**LAND NORTHEAST OF M1
JUNCTION 22,
MARKFIELD,
LEICESTERSHIRE**

**WHITWICK ROAD/A50
WESTBOUND SLIP ROAD**

**UPDATED STAGE 1
ROAD SAFETY AUDIT REPORT**

**REQUESTED BY:
RIDGE AND PARTNERS LLP**

Appendix A

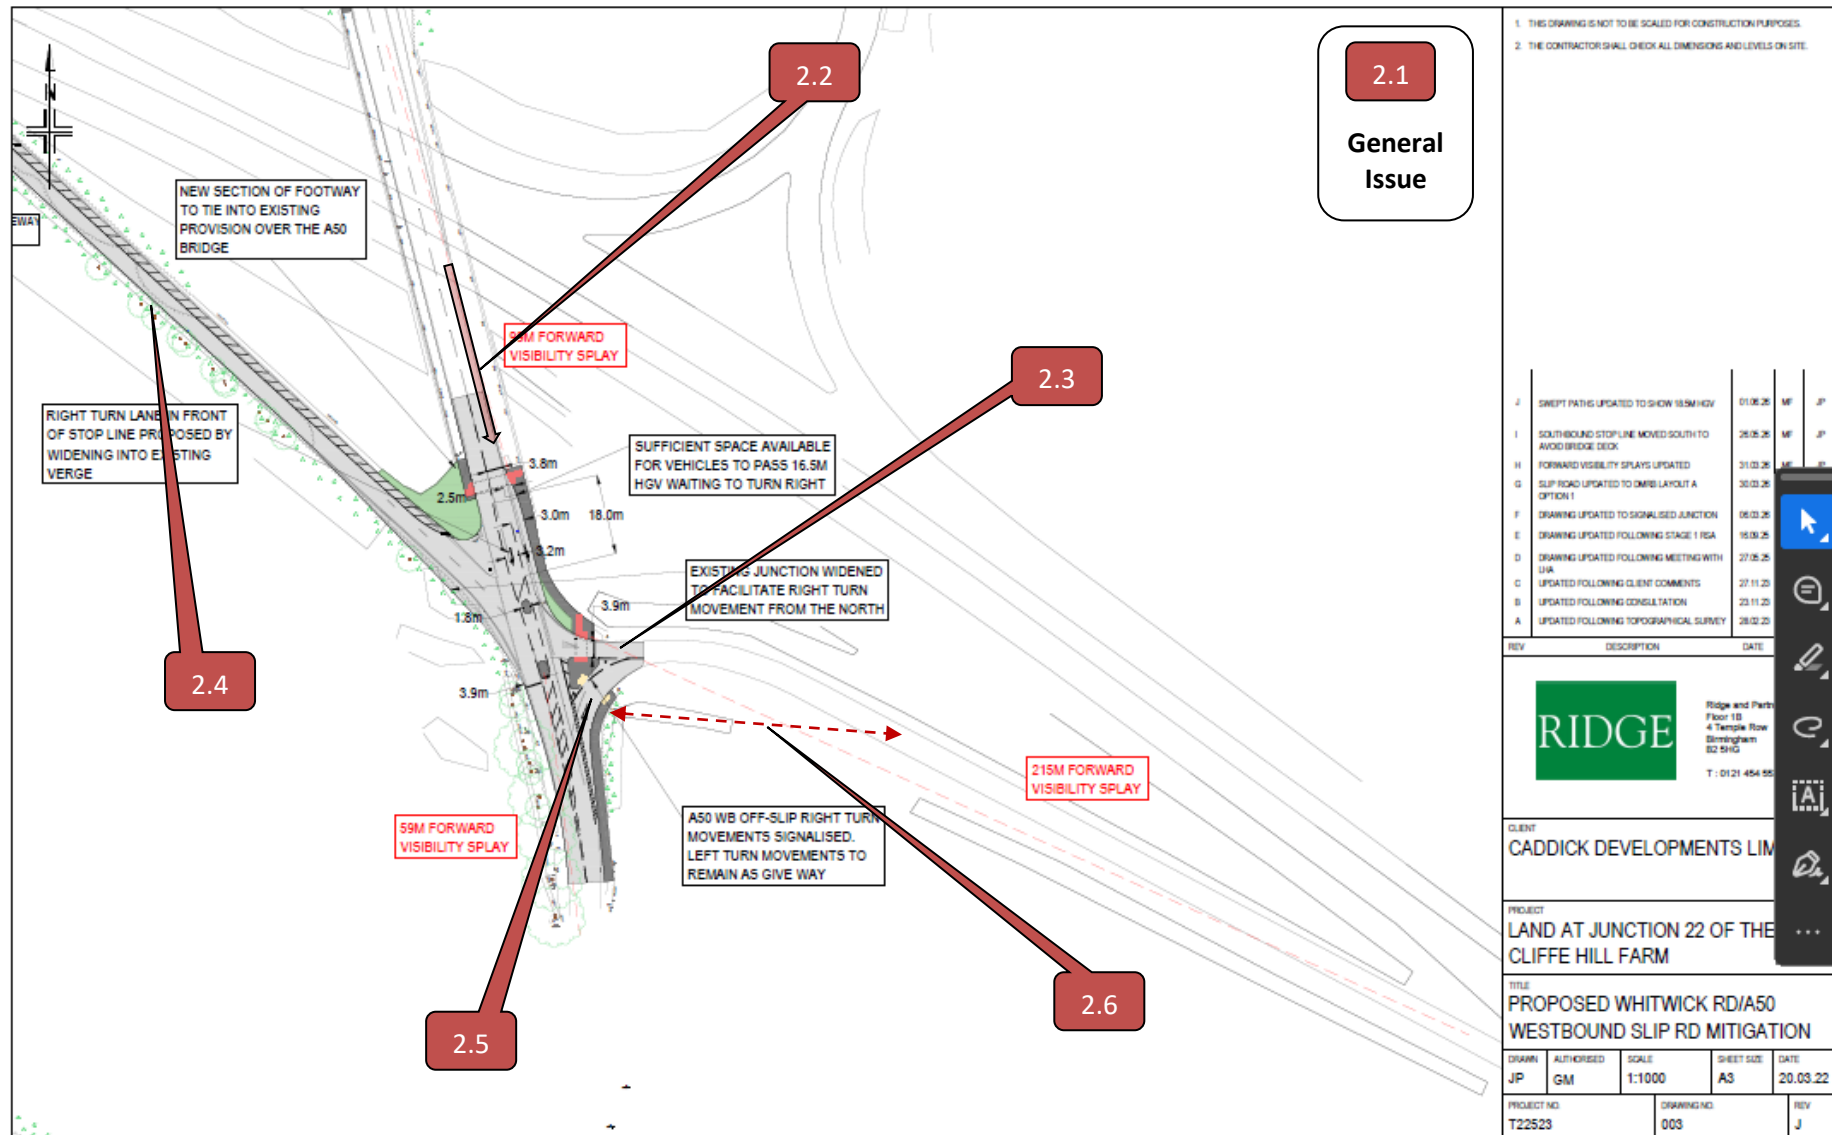
No details have been provided in respect of surface water drainage or other services, and it is therefore not possible to ascertain whether there will be any safety implications. The absence of surface water drainage may result in the collection of surface water which could increase the risk of loss of control collisions.

There is concern that the horizontal alignment of Whitwick Road southbound approach to traffic signal-controlled junction results in a deviation for vehicles continuing ahead. The deviating in the horizontal alignment may result in vehicle traveling ahead from north to south to collide into the proposed central island in front of the right turn lane or may result in loss of control collisions as motorists make sudden movements to avoid the central island.

There is concern that the partial signalisation of the A50 westbound off-slip left-turn may lead to driver confusion with the combination of signal control and give-way operation within the same junction. The layout and operation may not be clear to all users, particularly for those unfamiliar with the arrangement. This may result in inappropriate or hesitant manoeuvres with motorists incorrectly assuming signal control applies to all movements or failing to give way where required which may lead to an increased risk of sideswipe, rear-end, or shunt-type collisions.

Observations during the site inspection noted that vegetation between the A50 westbound on-slip and the A50 where vehicles will merge onto the A50 may be restricted by vegetation. Poor visibility for vehicles attempting to merge onto the A50 may increase the risk of sideswipe collisions between vehicles inadvertently merging onto the A50 and A50 westbound through traffic.

There is concern that the combination of controlled and uncontrolled pedestrian crossing facilities across the A50 westbound off slip is poorly defined and may lead to confusion for pedestrians. Consequently, pedestrians may inadvertently attempt to cross the junction at inappropriate times, increasing their exposure to traffic and the likelihood of being struck by passing vehicles. Road safety may be further compromised where pedestrians crossing the A50 off-slip left-turn lane from south to north misinterpret a green signal aspect at the controlled crossing as applying to their movement. This could result in pedestrians entering the carriageway when traffic on the left-turn slip lane is not required to stop, increasing the risk of conflict

There is concern that the no details in relation to the visibility splays to and from the proposed tactile landings at the uncontrolled crossing facility across A50 westbound off slip have been provided. Poor visibility for pedestrians using the crossing may encourage them to step out onto the carriageway to observe oncoming vehicles which may increase the risk of them being struck by turning vehicles.

Ensure that the detailed design incorporates surface water drainage to mitigate localised flooding/ponding.

Review and amend the layout to provide a smooth horizontal alignment for vehicles traveling ahead from north to south along Whitwick Road.

Review and amend the layout to ensure that the traffic control arrangement is clear and intuitive for all road users. If possible, the left-turn movement from the A50 westbound off-slip onto Whitwick Road south should be signal controlled to provide a consistent form of control across the junction and reduce the potential for driver confusion.

Ensure that Vegetation between the A50 westbound on-slip and the A50 is cut back and regularly maintained.

Review the layout, it would be more appropriate to provide a fully controlled pedestrian crossing facility across the A50 off-slip arm.

Review the layout to ensure visibility splays to and from the tactile landings are provided any obstructions in the visibility should be removed.

PROPOSED WHITWICK RD/A50 WESTBOUND SLIP RD MITIGATION

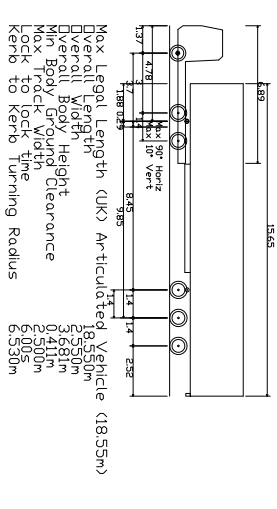
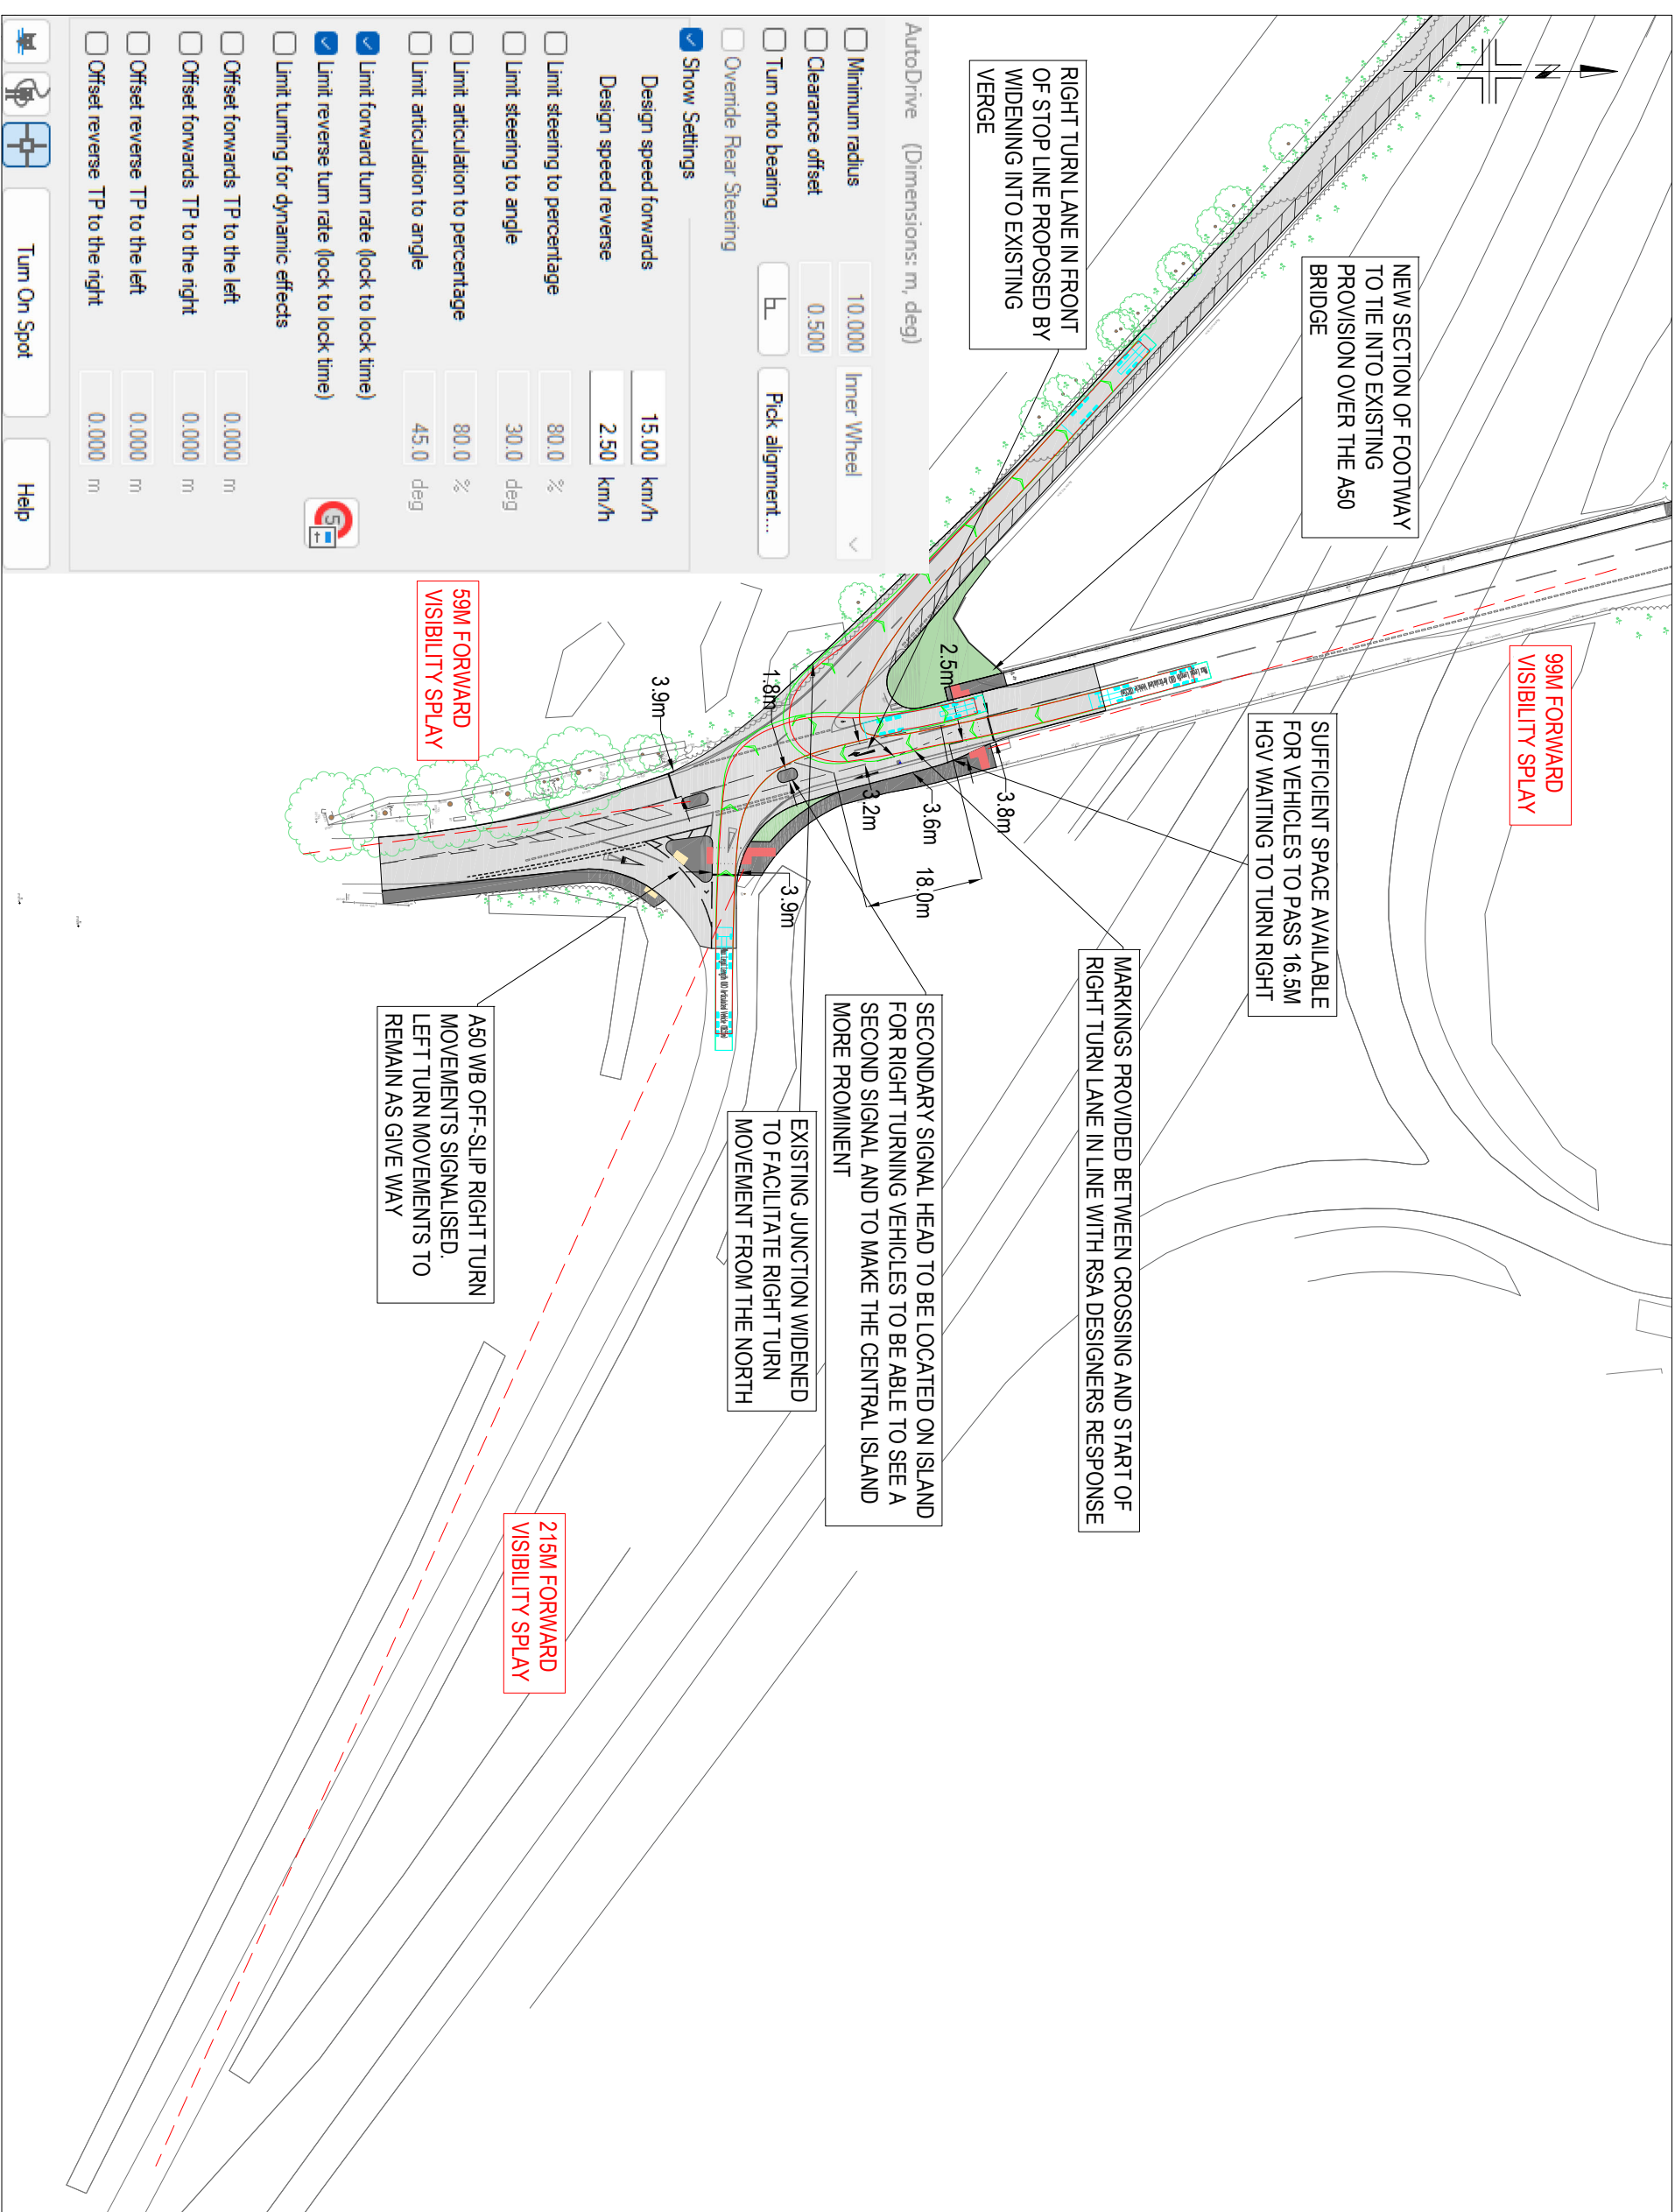
2.2	There is concern that the horizontal alignment of Whitwick Road southbound approach to traffic signal-controlled junction results in a deviation for vehicles continuing ahead. The deviating in the horizontal alignment may result in vehicle traveling ahead from north to south to collide into the proposed central island in front of the right turn lane or may result in loss of control collisions as motorists make sudden movements to avoid the central island.	Review and amend the layout to provide a smooth horizontal alignment for vehicles traveling ahead from north to south along Whitwick Road.	Accepted. It is proposed that a white dashed line is provided between the pedestrian crossing studs and the right turn lane to guide southbound vehicles through the junction. This adopts the same principle as the High Street and Tamworth Road approaches to the Tamworth Road/Burton Street/High Street traffic signal junction in Measham (LCC area) where no PIAs have been recorded in the latest five-year period (source: CrashMap). A secondary signal head is also proposed to be placed on the central island, which will make the central island more prominent (and to also provide a second signal for right turning vehicles waiting in front of the stop line); the final details will be confirmed as part of the detailed design stage. A note has been added to Drawing T22523.003 rev K. Additionally, forward visibility to the junction from the north is very good and will provide drivers plenty of time adjust their speed and react to the layout accordingly. Therefore, no further design changes have been made.

2.3	There is concern that the partial signalisation of the A50 westbound off-slip left-turn may lead to driver confusion with the combination of signal control and give-way operation within the same junction. The layout and operation may not be clear to all users, particularly for those unfamiliar with the arrangement. This may result in inappropriate or hesitant manoeuvres with motorists incorrectly assuming signal control applies to all movements or failing to give way where required which may lead to an increased risk of sideswipe, rear-end, or shunt-type collisions.	Review and amend the layout to ensure that the traffic control arrangement is clear and intuitive for all road users. If possible, the left-turn movement from the A50 westbound off-slip onto Whitwick Road south should be signal controlled to provide a consistent form of control across the junction and reduce the potential for driver confusion.	Partly accepted. This layout is common at signal junctions across the UK and there are no inherent safety issues with this type of layout. The proposed mitigation scheme would not require changes to driver behaviour for those who are turning left onto Whitwick Road from the A50 WB Off-Slip. Additionally, give way signs will be provided to reinforce the need for left turning vehicles to give way; the final location of which would be determined at the detailed design stage. Louvres can also be provided to reduce the likelihood of see through issues, which can be specified at detailed design stage. Therefore, no design changes have been made.

2.5	There is concern that the combination of controlled and uncontrolled pedestrian crossing facilities across the A50 westbound off slip is poorly defined and may lead to confusion for pedestrians. Consequently, pedestrians may inadvertently attempt to cross the junction at inappropriate times, increasing their exposure to traffic and the likelihood of being struck by passing vehicles. Road safety may be further compromised where pedestrians crossing the A50 off-slip left-turn lane from south to north misinterpret a green signal aspect at the controlled crossing as applying to their movement. This could result in pedestrians entering the carriageway when traffic on the left-turn slip lane is not required to stop, increasing the risk of conflict	Review the layout, it would be more appropriate to provide a fully controlled pedestrian crossing facility across the A50 off-slip arm.	Not accepted. The shortest walking distance between the two crossing points is c.4.5m, which is a sufficient gap for users to realise the two crossing points are not linked, and also for users to check for oncoming traffic. The alignment of the uncontrolled crossing is significantly different to the controlled crossing, which means that there would be no 'see through' issues. Therefore, no design changes have been made.
